Request for formal variation to the Chalumbin Wind Farm Project (EPBC 2021/8983)

Chalumbin Wind Farm Pty Ltd (CWF) seeks a formal variation to the Chalumbin Wind Farm Project (the Project) (reference EPBC 2021/8983), in accordance with the provisions of s156 of the *Environment Protection and Biodiversity Conservation Act 1999* (EPBC Act).

Chalumbin Wind Farm
 Notable MNES Constraints and Current Project Layout

Figure 1

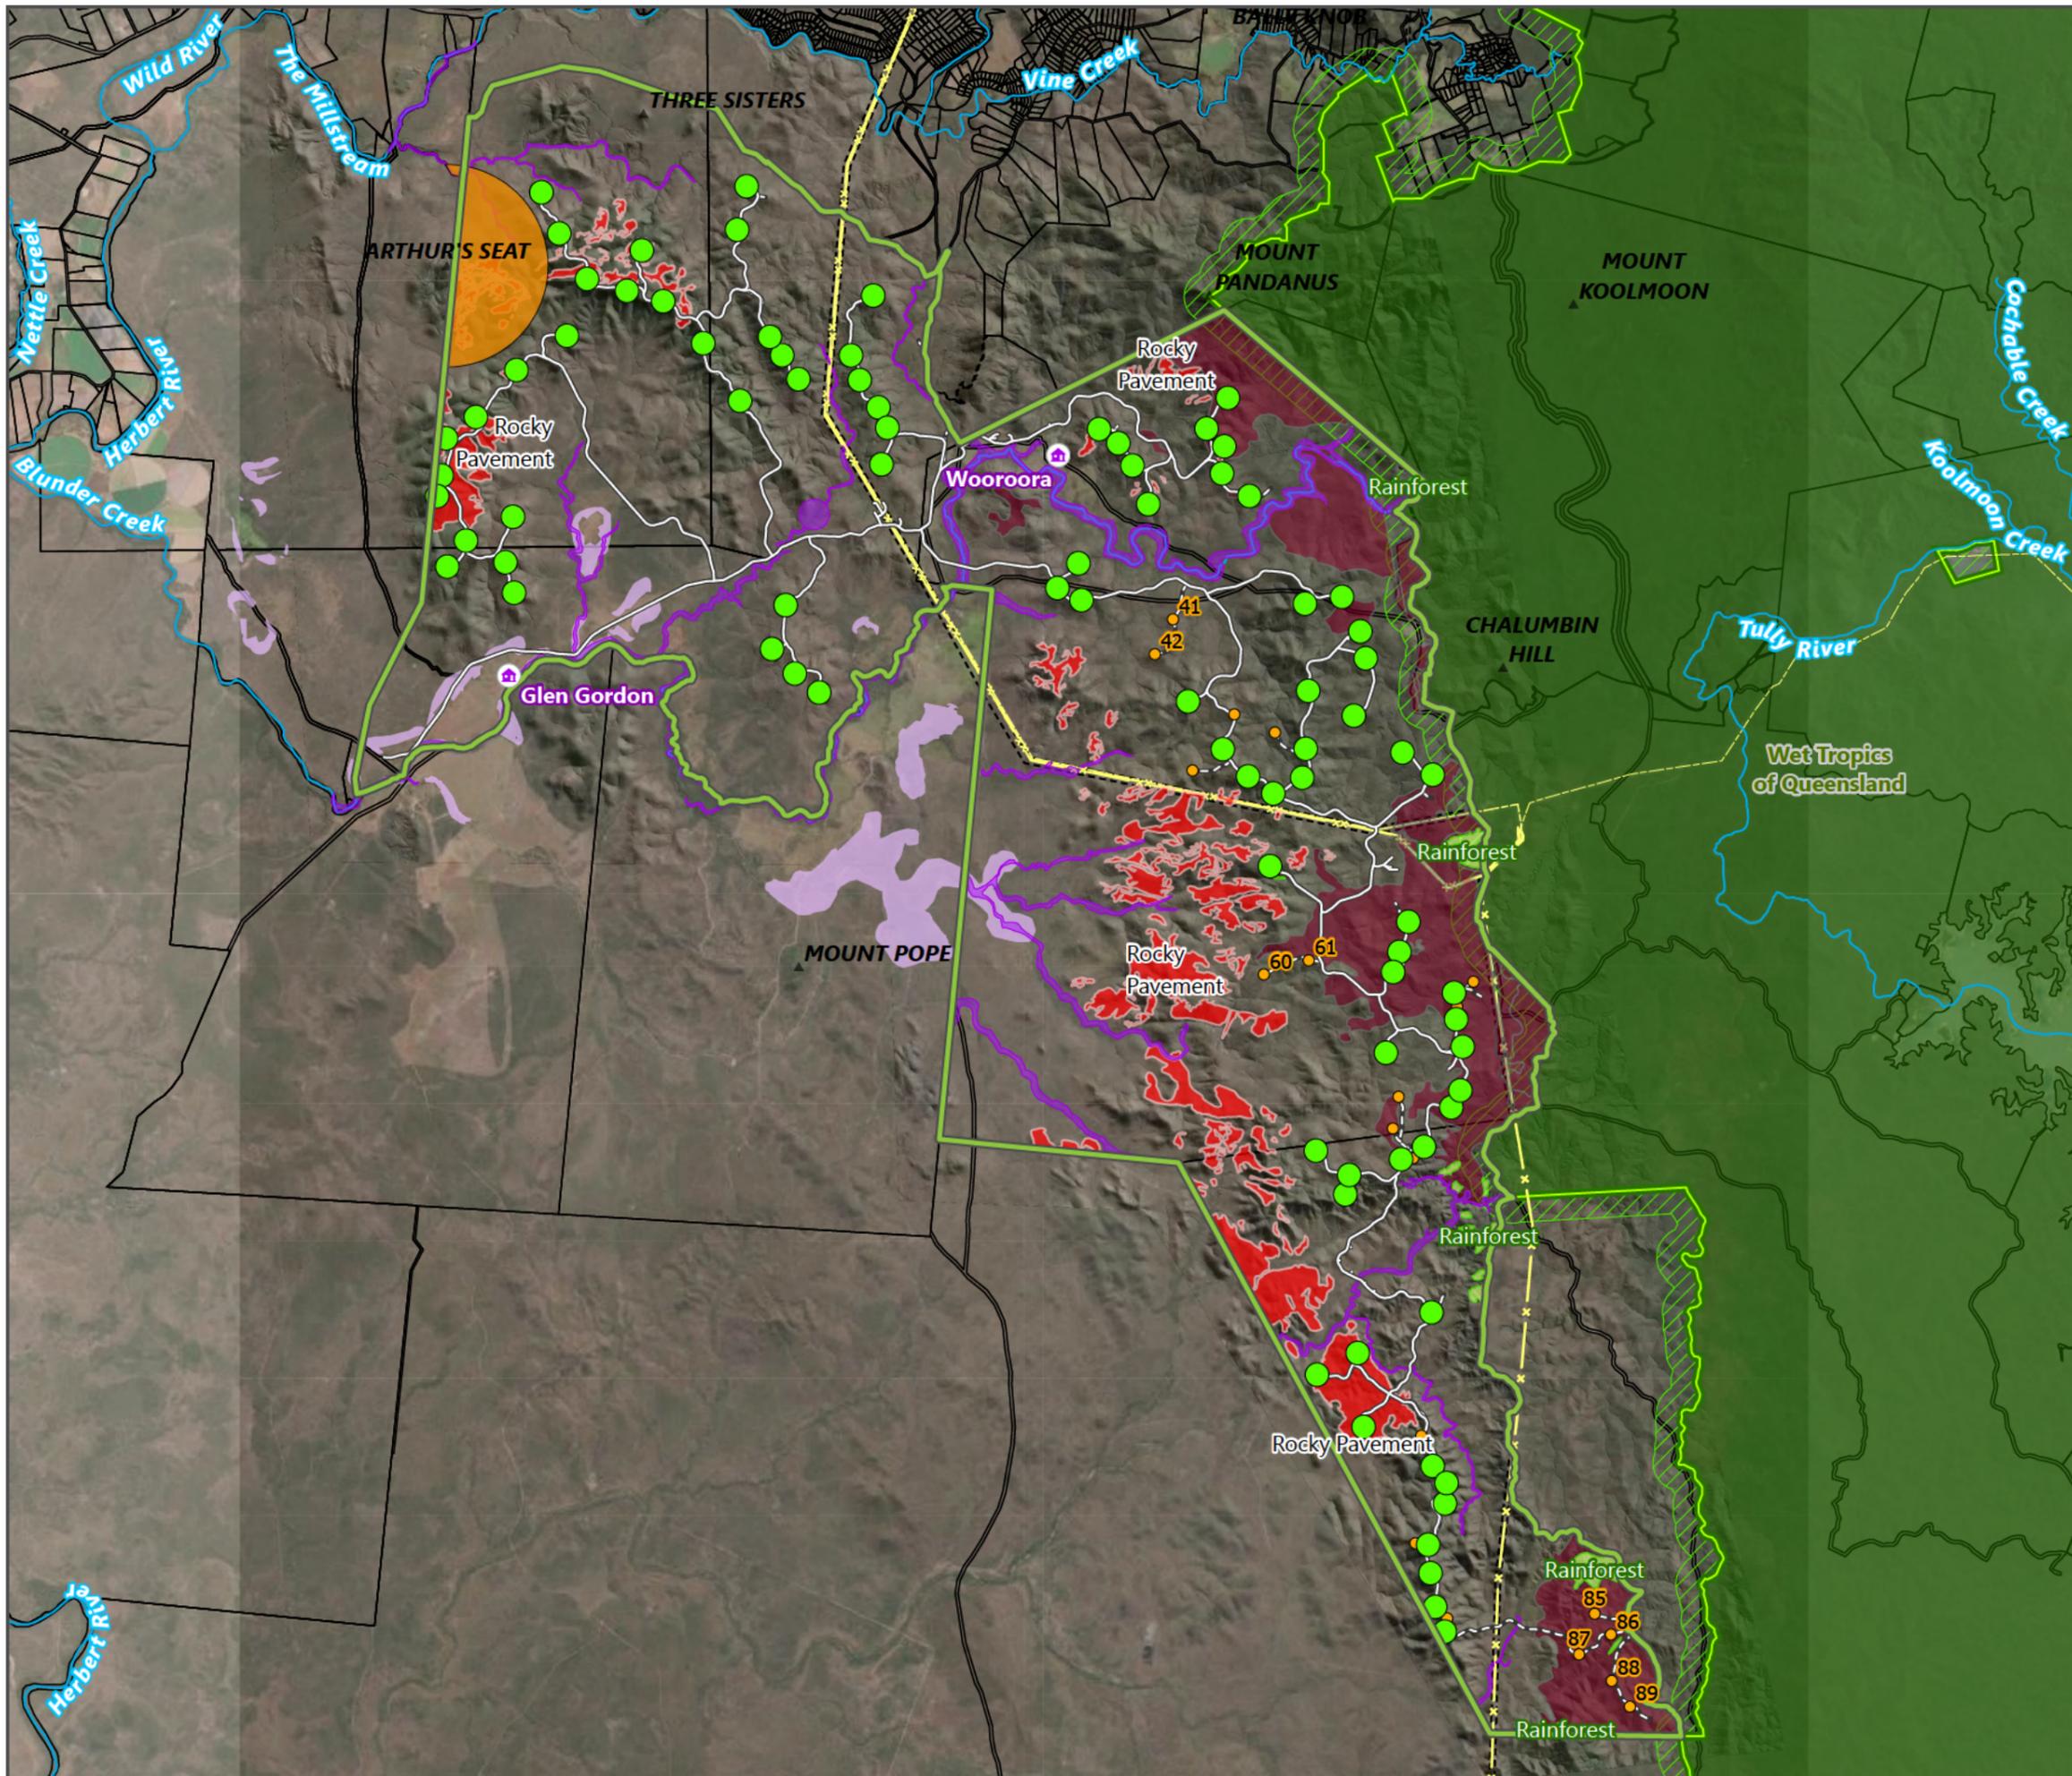
The differences between the Project footprints at the Referral stage and the Draft PER stage are presented spatially in **Figure 2-1**. Spatial files of both Project footprints are also provided with this letter.

Following further studies and stakeholder engagement since that time, the following significant changes have been made:

- Removal of 9 wind turbines (from the Referral's 95), reduction in access tracks by 27 km and relocation of the southern sub-station, which reduces the internal overhead transmission line by 4 km. These changes reduce clearing overall by 5%, and importantly the potential impacts to wet sclerophyll forest are reduced by 31%;
- A significant increase in biodiversity offsets to ensure a net positive impact, including three large areas totalling more than 7,400 ha, primarily located immediately adjacent to the Wet Tropics of Queensland World Heritage Area (WTQWHA). This includes the largest patch of intact wet sclerophyll forest adjacent to the Tully Falls National Park and creates connectivity between Koombaloo National Park and Yourka Reserve Nature Refuge;
- Commitment to avoid ground-disturbing works in the highest rainfall months of January, February and March;
